February 17, 2017

**ADDENDUM #2
8TH STREET ROAD IMPROVEMENT PROJECT
CITY OF CHATTANOOGA CONTRACT # T-16-014-201**

SHEET NUMBER: **C-13**

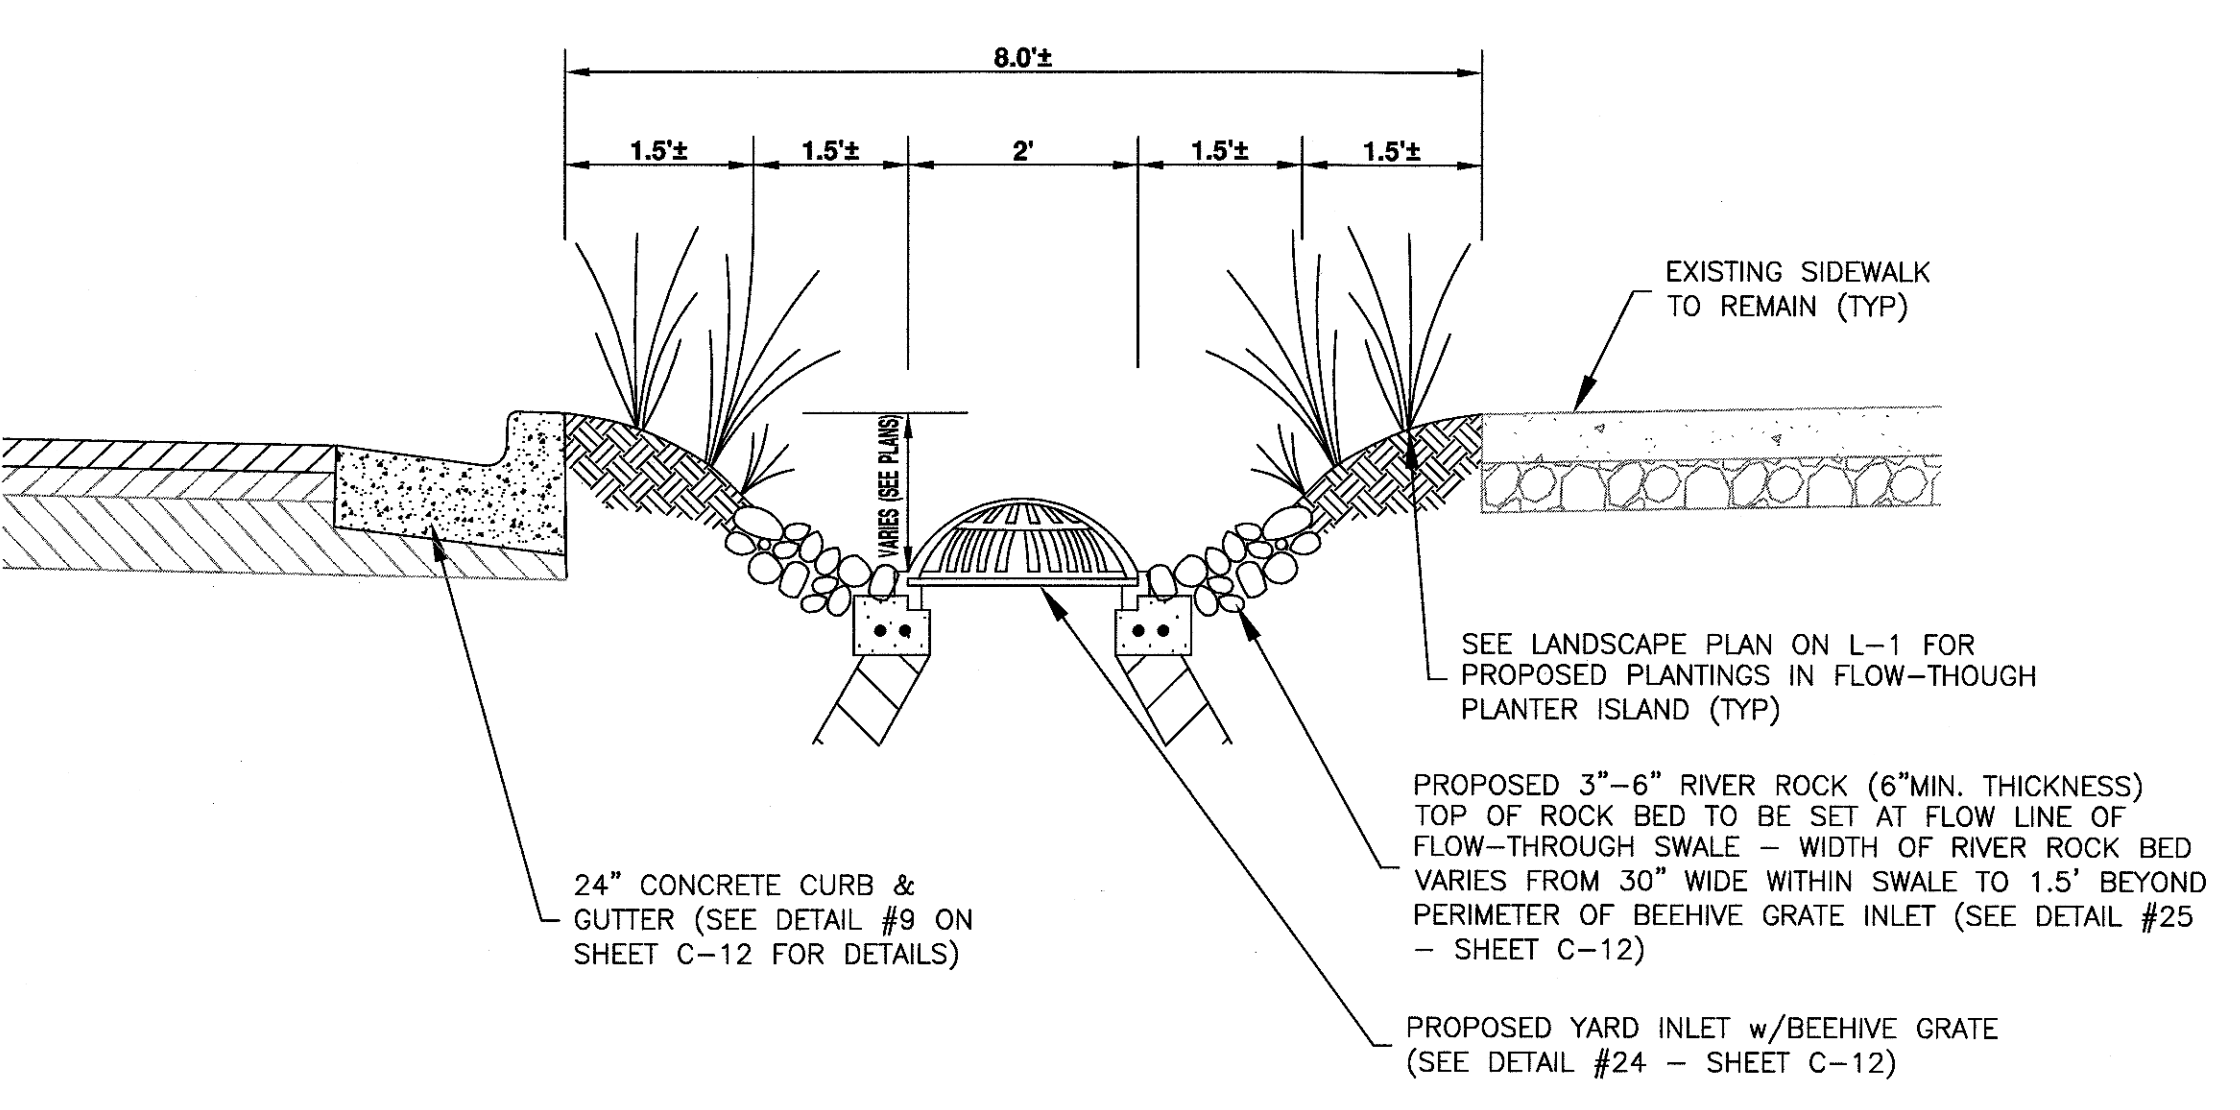
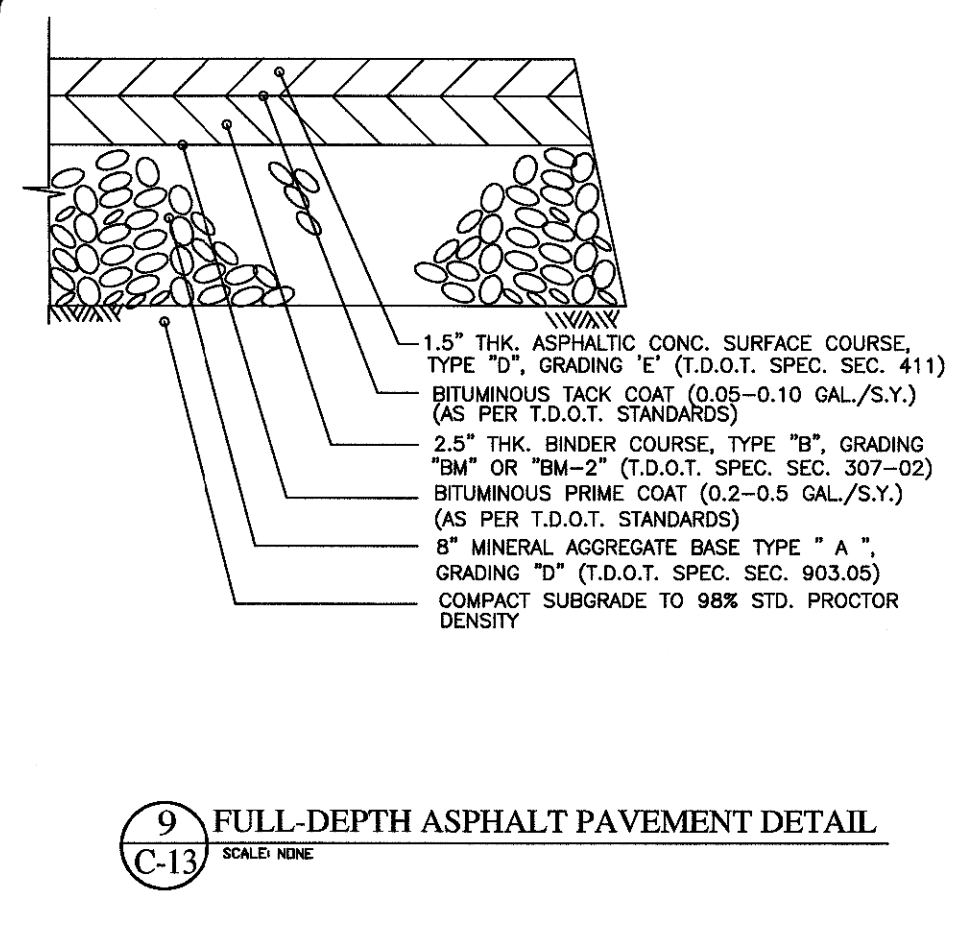
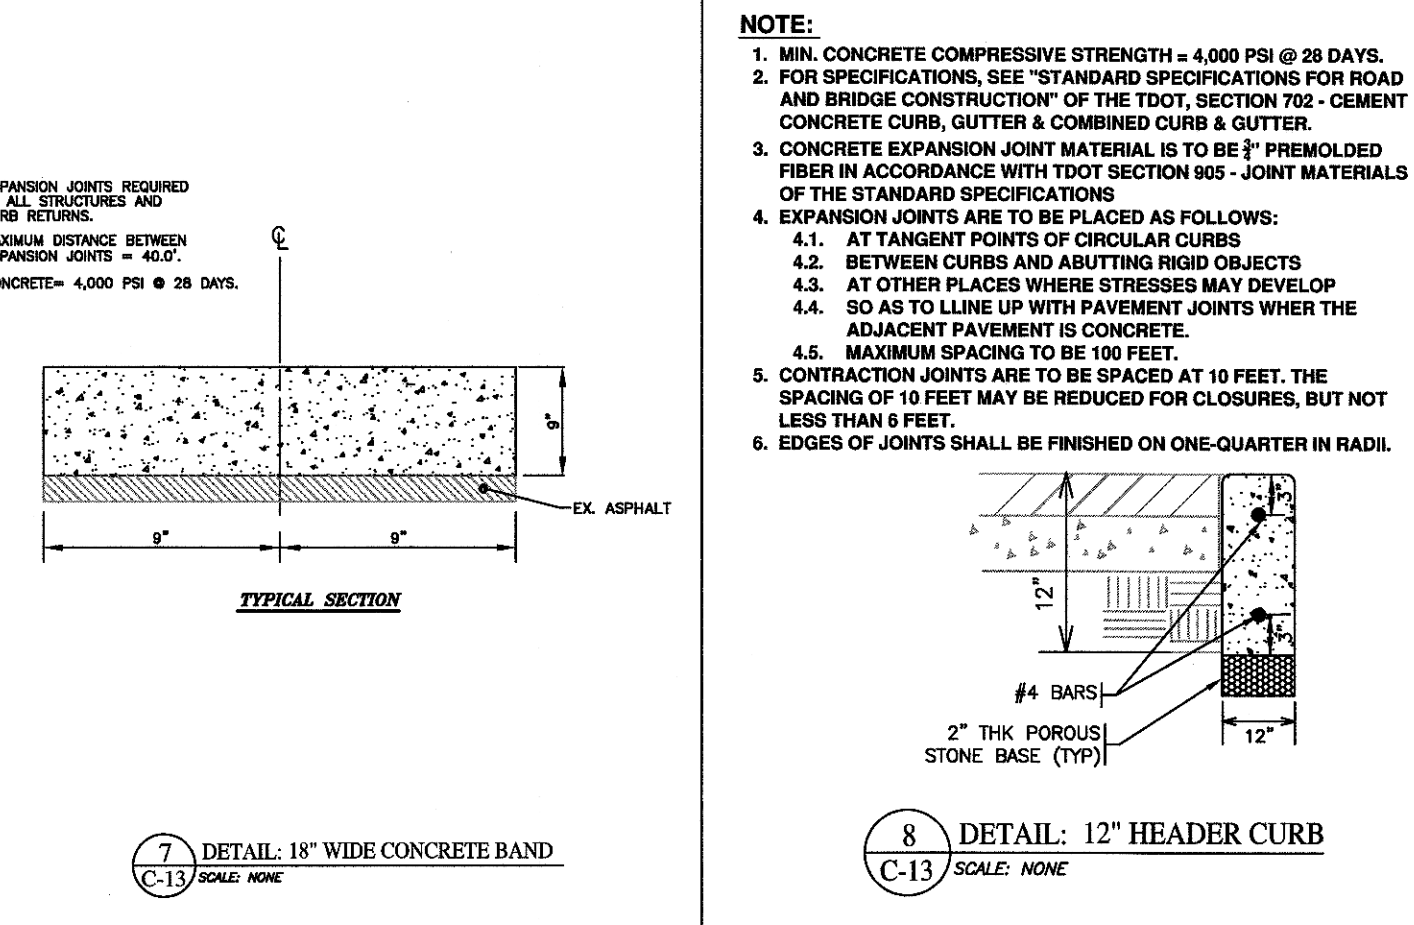
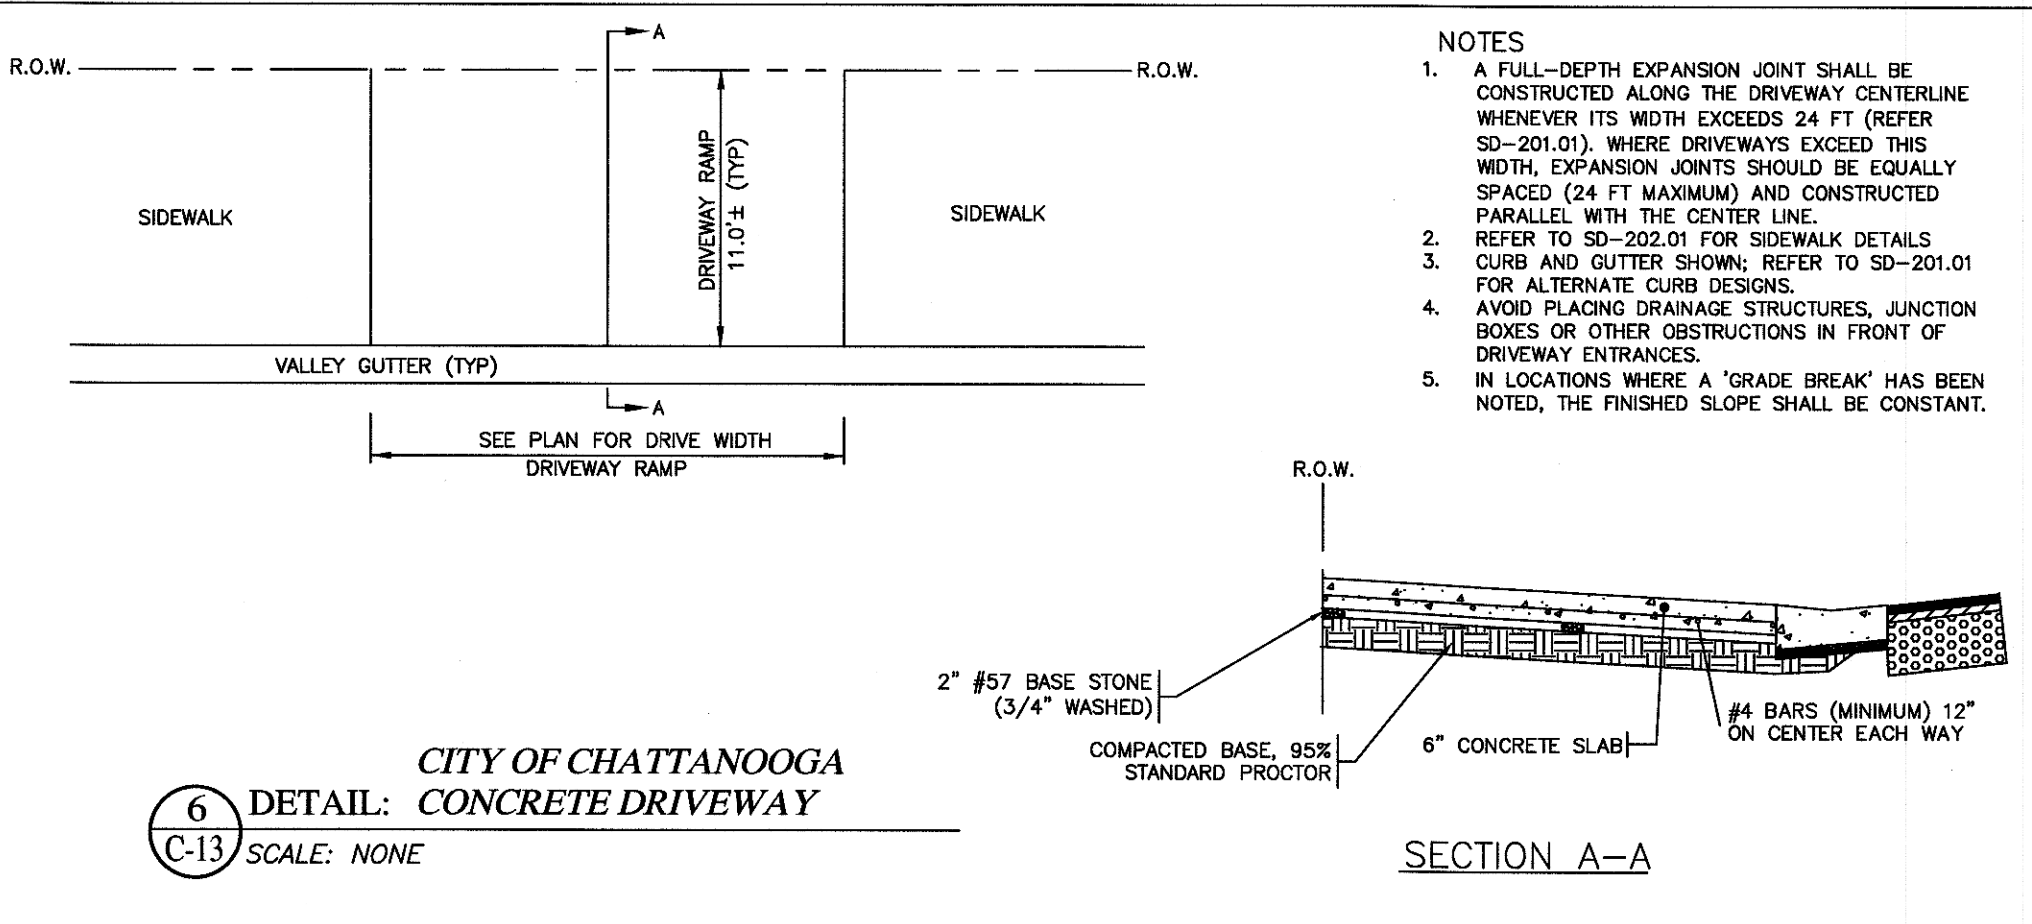
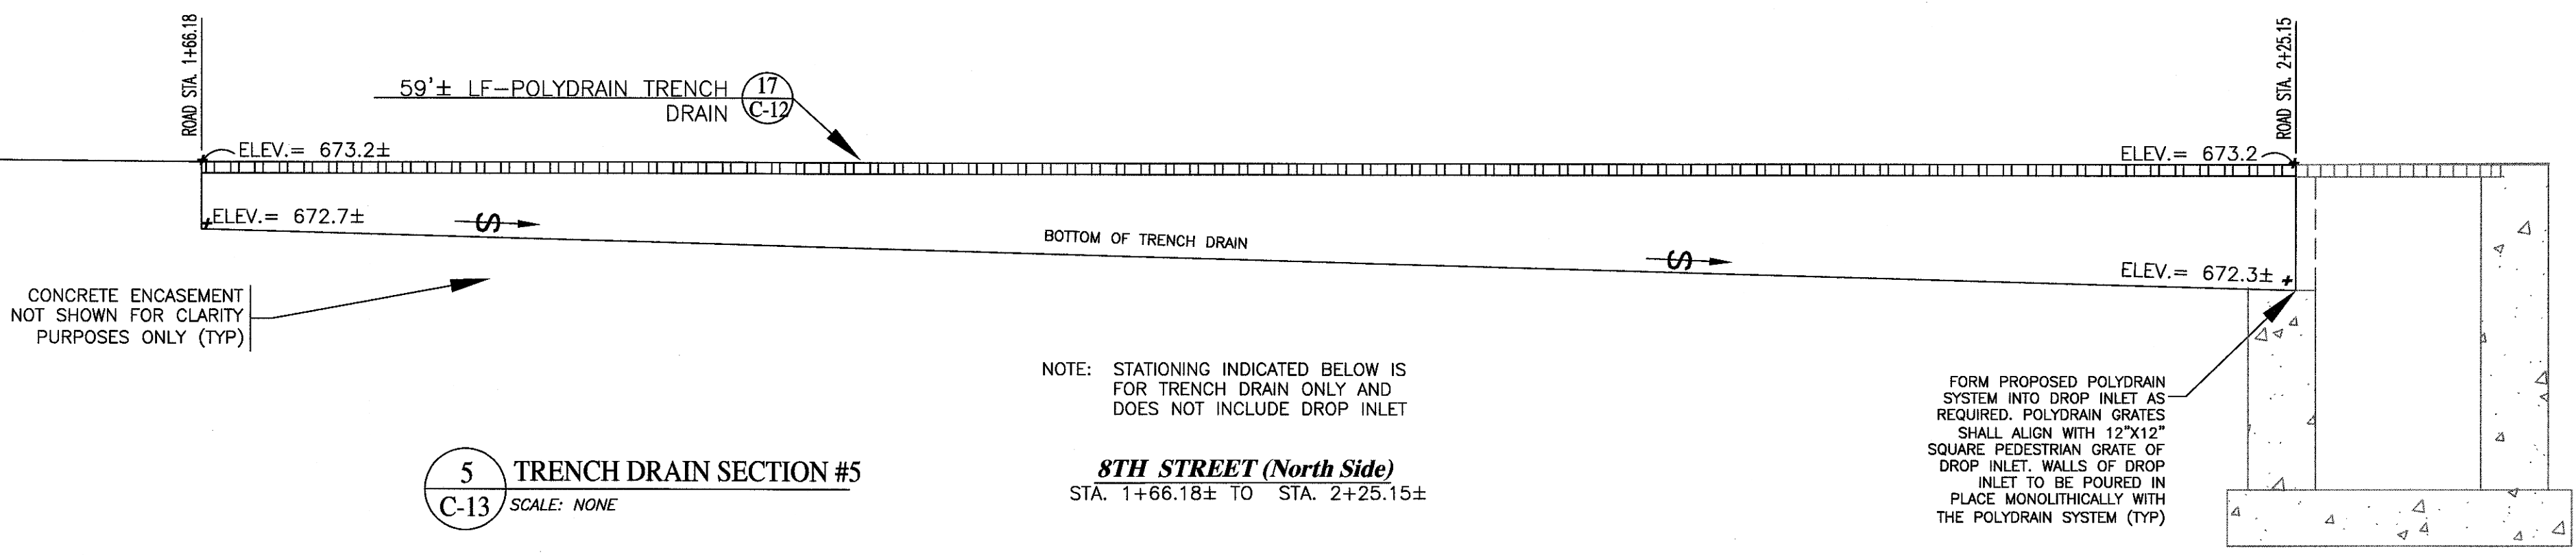
- Item #5.** Clarification: A full-depth asphalt pavement section was reflected on Sheet C-13 as part of Addendum #1. Finished grade elevations and/or storm drainage installation may require full-depth paving. Limits of full-depth pavement shall be determined in the field by contractor and

Item #18. Replace Sheet C-13 – Site Details (Originally dated 01/13/17) – with attached Sheet C-13 – Site Details (Revision #2 dated 02/16/17). Note the revisions consist of:

- Amending Detail #9 to reflect the full-depth pavement section of 8/2.5/1.5 as indicated.

confirmed by the Engineer. Please see the enclosed revised bid schedule to reflect the revised unit price line item for full-depth pavement specification.
